INTRODUCTION:

This bulletin announces availability of a redesigned stay (reinforcement) to address isolated customer concerns of a creaking-type sound from the r/rear seat cushion / backrest hinge area. The sound occurs when the stay contacts the backrest hinge assembly and can be heard when going over bumps and / or making a left turn when body twist is induced. The new part has extra clearance added to eliminate the contact.

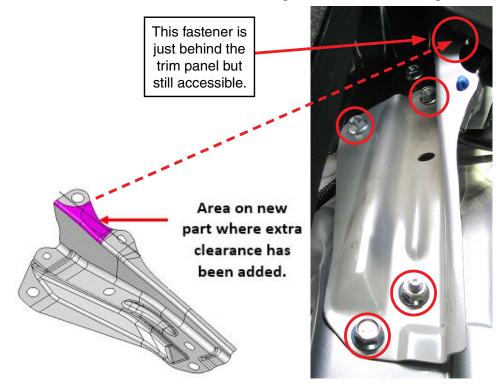
The new stay was incorporated into production starting with VIN H*821880.

The new stay part number is **52168VA0019P.** The illustrations and photo show the stay's location in the right rear floor section under the rear seat, fastener placement and the change to the new part.

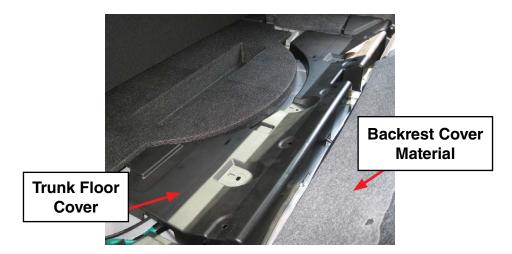
- Remove the rear seat cushion following the procedure in the applicable Service Manual.
- Using a trim clip tool, **CAREFULLY** remove the 4 retaining clips securing the backrest cover material then remove the trunk floor cover (3 clips) ahead of the spare tire well.

• CAREFULLY disengage the rear wheel speed sensor harness connector clip from the stay.

- Loosen the 5 fasteners then remove and discard the original r/rear stay.
- After the stay is removed, closely inspect the backrest hinge for any burrs as shown in the photo. If any are found, they must be removed with a file. Clean and dry any bare metal spots created with a mild solvent on a clean shop cloth. Always treat any exposed bare metal spots created with a generic touch-up paint or self-etching primer to prevent rust.

- Install the new stay and torque all 5 fasteners to 21.5-22 Nm (16 ft. lbs.).
- Reassemble in reverse order of removal.
- Road test to confirm the repair.
